ABP-312275-21 – STRATEGIC HOUSING DEVELOPMENT AT ST. EDMUNDS, ST. LOMANS ROAD, PALMERSTOWN, DUBLIN 20

South Dublin County Council hereby sets out its Chief Executive's Report, including recommendations on the above Strategic Housing Development for An Bord Pleanála (ABP or The Board). The Board as the competent authority has validated the application and will carry out an Appropriate Assessment Screening of the proposed development and will decide to grant or refuse permission for the proposed development.

IMAGE 6- MASSING MODEL- PROPOSED AMENDMENTS IN BLUE

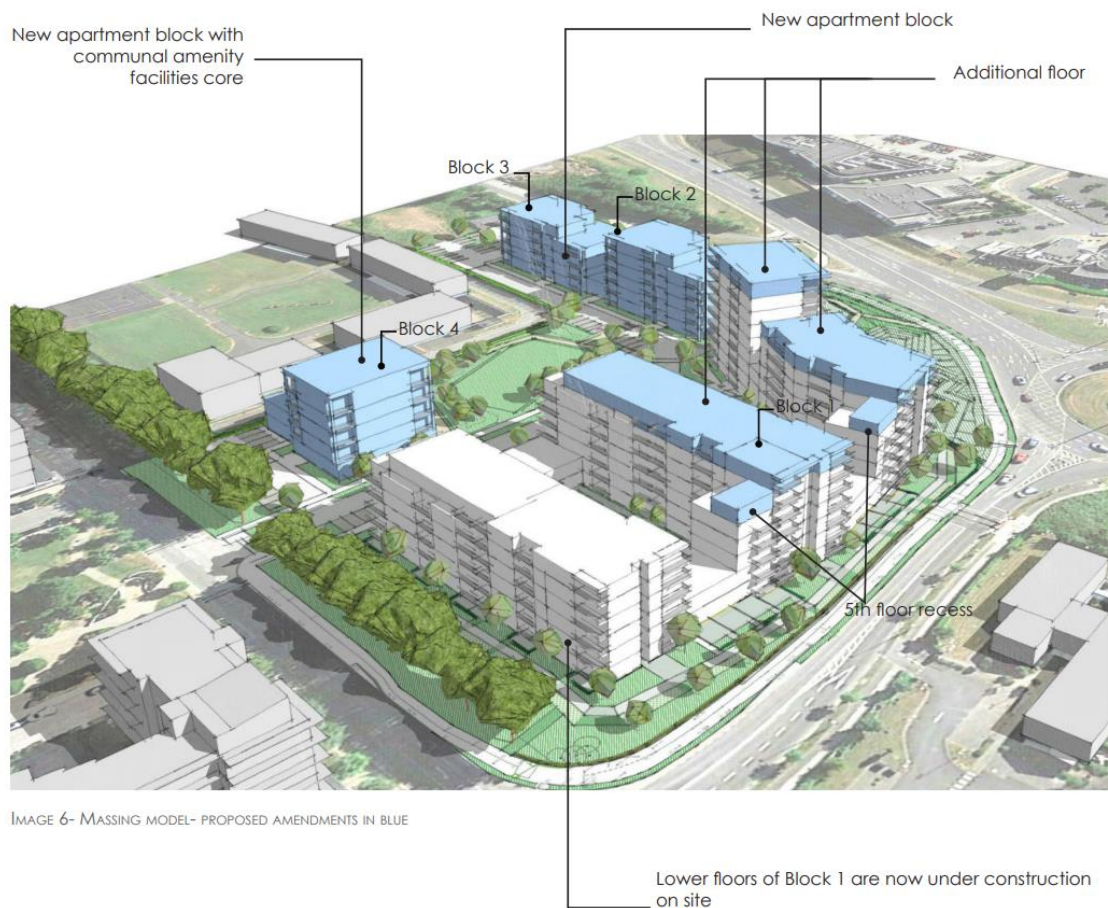
These amendments are assessed further in the following sections of this report. It remains the view of the Planning Authority that the development would benefit from a small retail unit for basic day to day needs. This is discussed further in this report.

The Planning Authority considers that the proposed development materially contravenes the building height provisions of the County Development Plan.

It is acknowledged that the subject site is not identified for tall buildings exceeding five storeys in an approved plan (as per Policy H9 Objective 4 and Policy UC6 Objective 3). Blocks 1 and 2 would exceed 5 storeys by 4 storeys and 1 storey respectively. As stated previously, the Planning Authority considers there to be a material contravention in relation to these height provisions. Block 4 has not been

Block 3 has been increased in height from the permitted 2 storeys to 4 to 5 storeys. This building would be approx. 32 m from the permitted Part 8 housing scheme to the north. It is considered that the provision of increased height above 2 storeys within 35m of the permitted 2 storey dwellings is contrary to a criterion contained in the implementation section of the County Development Plan. (Section 11.2.7).

Permeability:

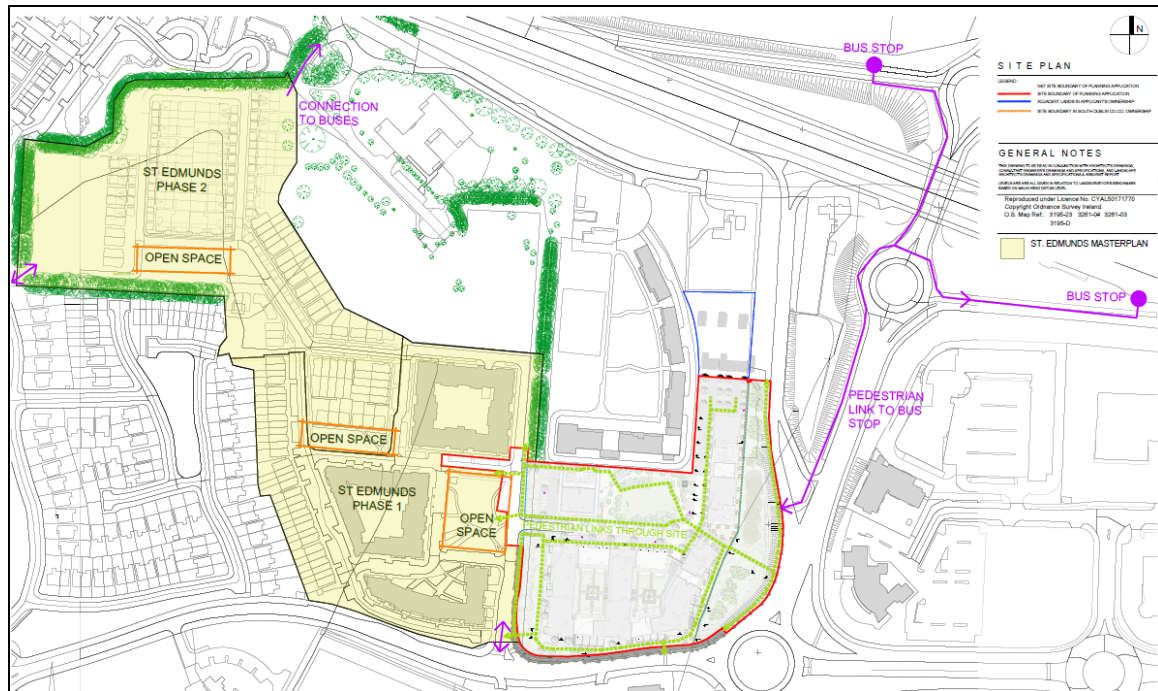
There are 2.0m wide footpaths on both sides of St Loman's road. An existing bus layby is provided adjacent to the westbound carriageway of St. Loman's Road. There is an existing Toucan crossing to the east of the existing site access. There will be a few proposed pedestrian entrances along St. Loman's Road, the Fonthill Road (R113) and the unnamed road to the west of the development. A pedestrian route through SDCC lands is to be developed linking to the pedestrian crossing on the Fonthill road.

ABP requested the following information:

RMDA Landscape Rationale provides a plan of linkages through the site. This includes routes through the site, and the extension of the new public footpath to the north in SDCC land ownership for which a letter of consent has been received. MCORM Architects have also provided a Masterplan drawing providing routes from the site into the wider area including public transport.
